### Environmental Conditions at Michigan Metroplex Processing and Distribution Center

### Management Advisory Report

Report Number  
HR-MA-17-001

## PASSIVE VENTILATION SYSTEM WITH SENSORS TO DETECT METHANE

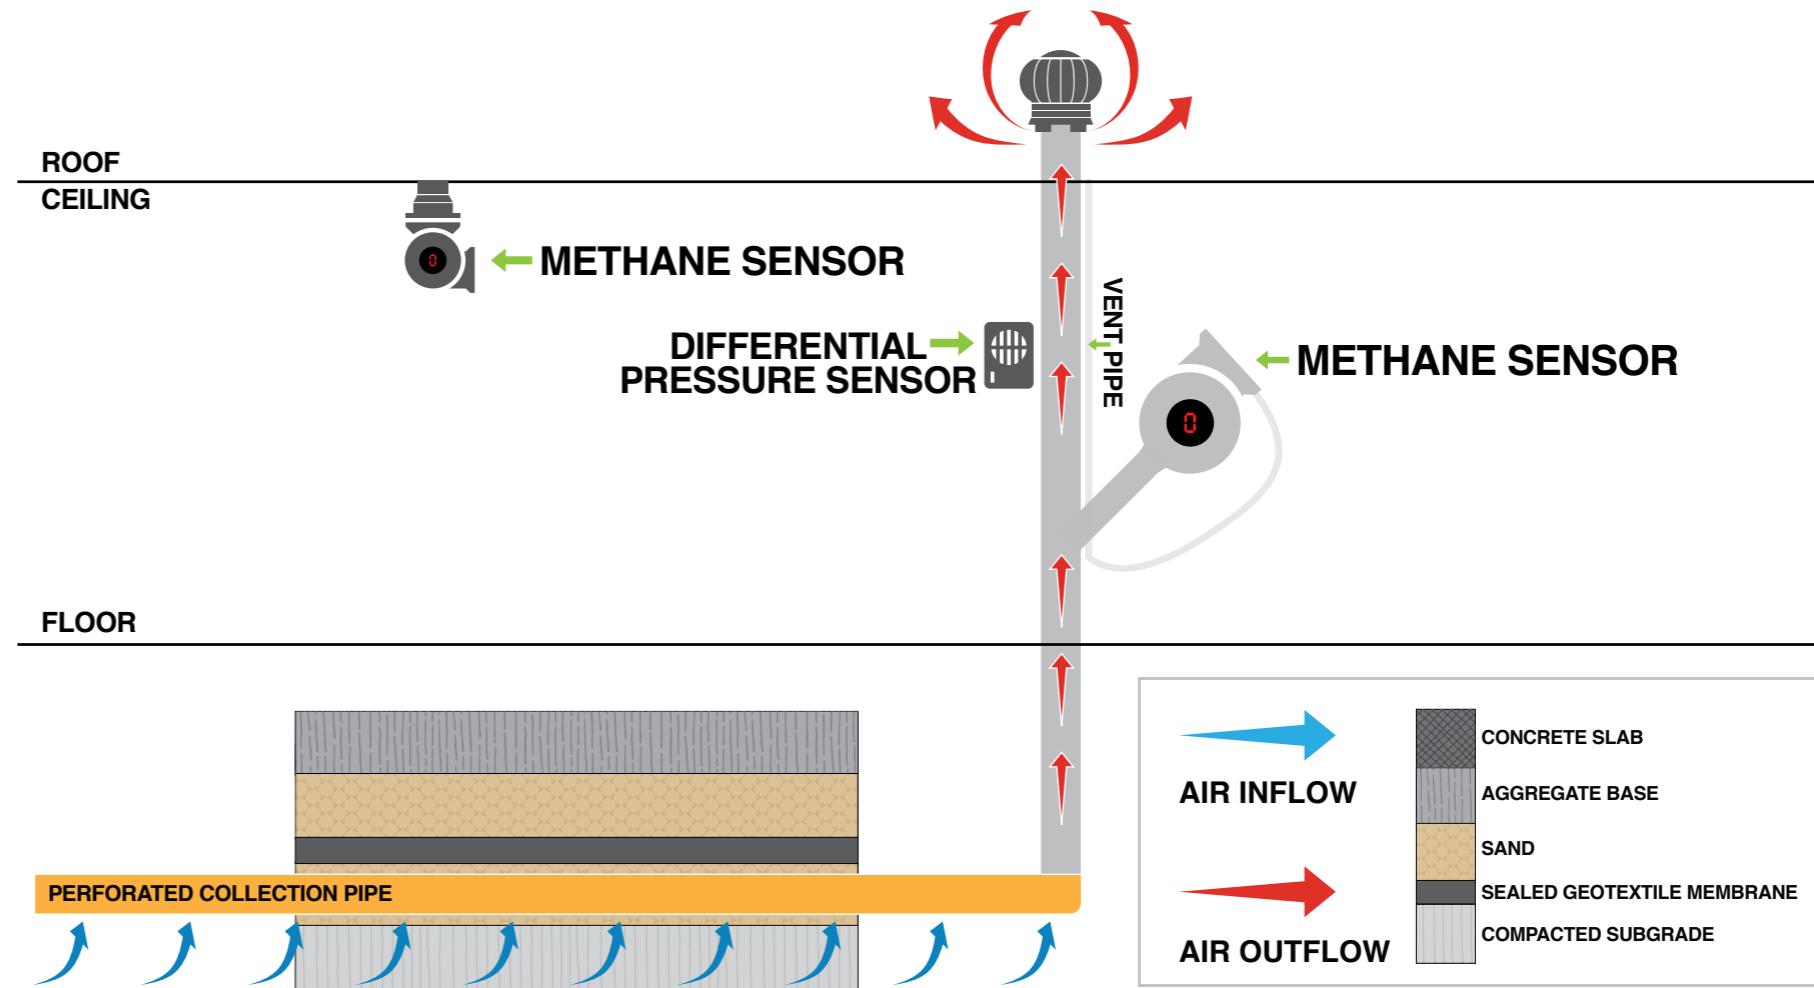
- Four sensors in the ventilation pipes that monitor and detect pressure differences between the subslab and indoor air did not have alert notifications for increases in relative pressure differences due to weather changes and events that may cause vapor intrusion into the facility. We observed excessive differential pressure levels during our site visits and no alarms or alerts were triggered. In their response to this report, management provided documentation to show the system was set for notification if the building experiences negative pressure for 5 consecutive minutes. Further, no action is needed once the system is converted from passive to active, as an active system will mitigate the pressure in the pipes.

- Spacing between the collection pipes is greater than 50 feet and may not effectively collect and passively vent accumulated gases from beneath the building. However, given the Postal Service's plans to convert the methane detection system from passive to active at the two vent stack locations, no further action is needed regarding this issue.

We recommended management finalize conversion of the methane venting system from passive to active, develop a process to check the sensor calibration, provide training on the methane detection system to responsible personnel, and update the operating manual.
